County of Santa Cruz

Subject: Public Hearing to consider appeal of the Planning Division's completeness determination for application #251393, a Coastal Development Permit to remove excess landslide debris from the bluff face and to construct debris flow fencing and drainage improvements behind an existing retaining wall in the rear yard.

**Attachment 5
Application 251393**

LANDSLIDE MITIGATION FOR ELAN & MAUREEN SHEINMAN 303 BEACH DRIVE, APTOS, SANTA CRUZ COUNTY, APN #043-082-70
GRADING & DRAINAGE PLAN

C-2

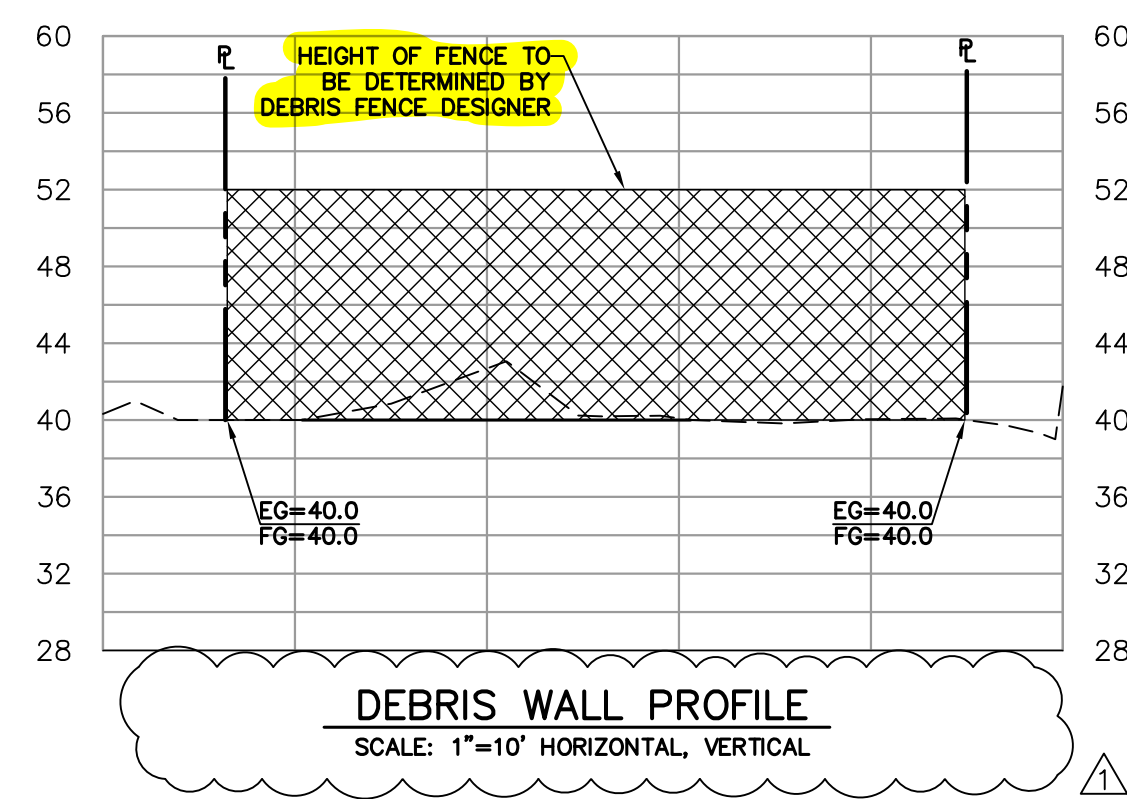
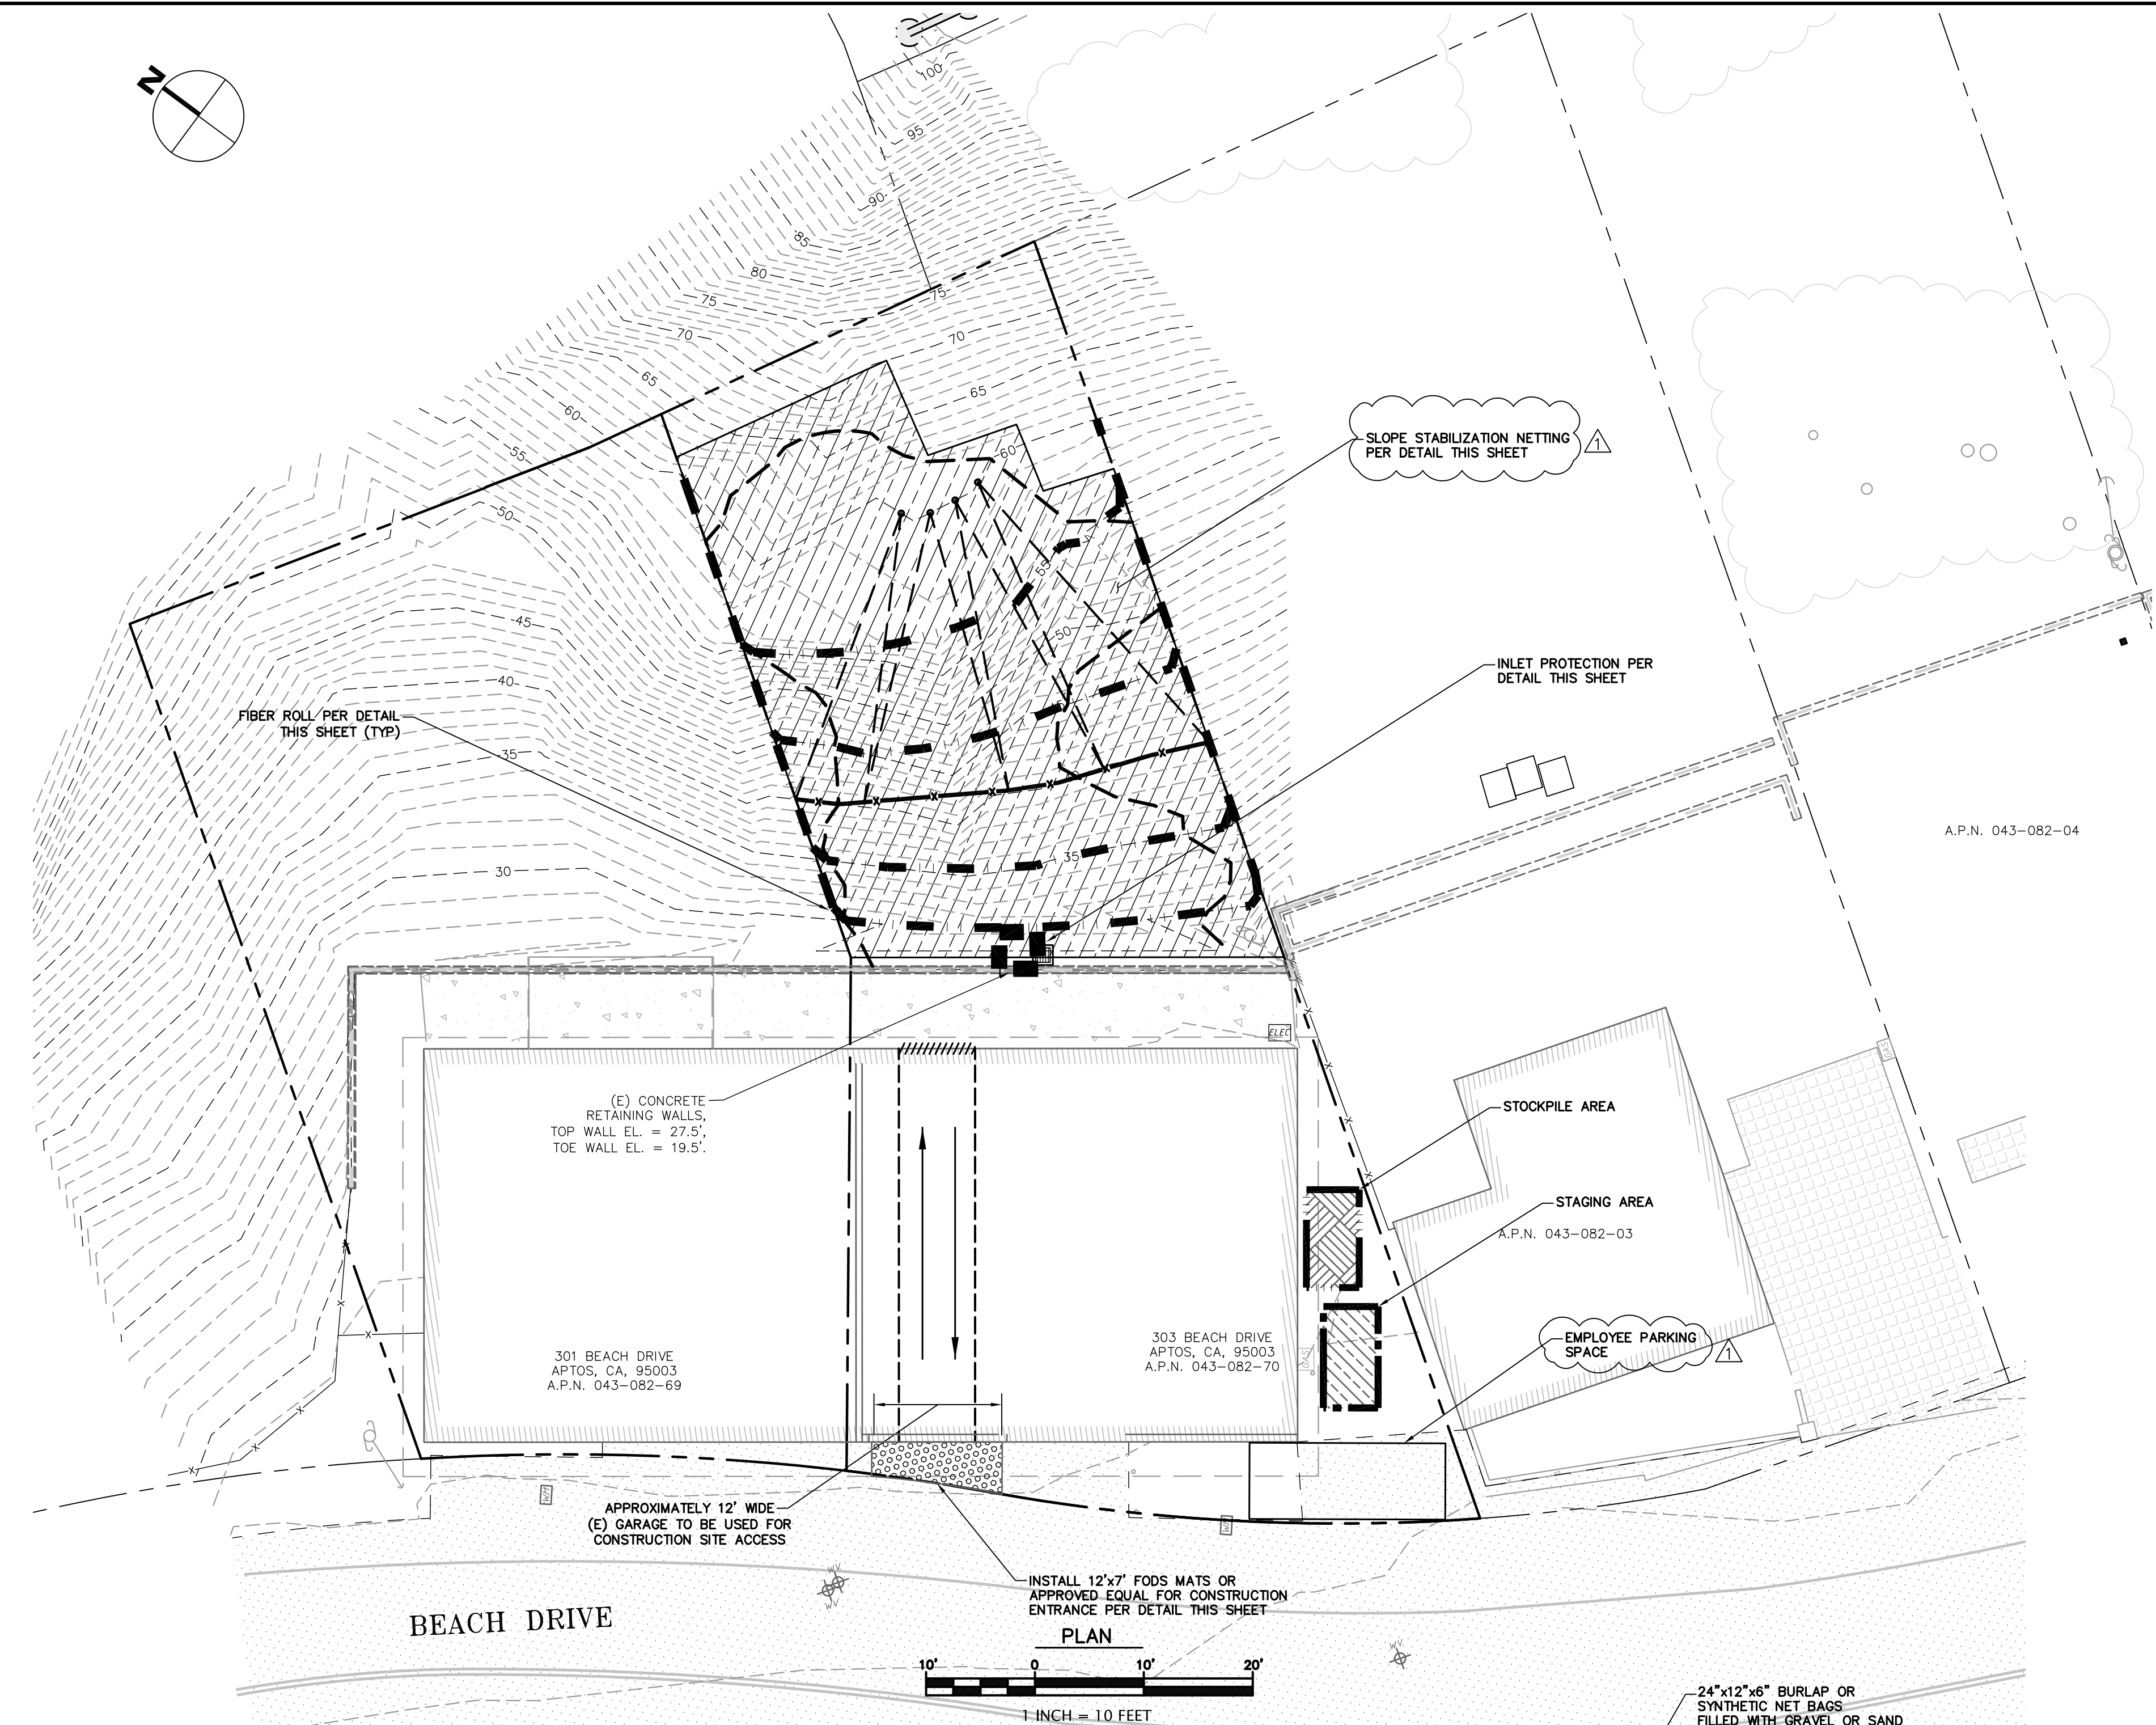
- "Universal List of Required Information (LORI) item 2(f): Structures and site improvements are required to be drawn to scale. The response letter and sections on Sheet C-2 indicate that the location of the fence is 10 to 15 feet from the existing retaining wall and the height of the wall is yet to be determined. Please provide some additional clarification on the anticipated range of heights or setbacks proposed for the debris wall."

1. Please submit full and complete sets of revised plans which include the following information:
 - a. Universal List of Require Information (LORI) item 2(f): Structures and site improvements are required to be drawn to scale. The response letter and sections on Sheet C-2 indicate that the location of the fence is 10 to 15 feet from the existing retaining wall and the height of the wall is yet to be determined. Please provide some additional clarification on the anticipated range of heights or setbacks proposed for the debris wall.

2. Relating to Incomplete Item #a, it would be helpful to provide background information relating to how the design and location of the debris wall was determined, including what factors or constraints will influence the final design and location. Specifically, discussion is requested which speaks to how the height increases (or decreases) if the structure is sited at the existing concrete retaining wall versus 10-15 feet (or more) upslope. This discussion can be submitted as part of the alternatives analysis.
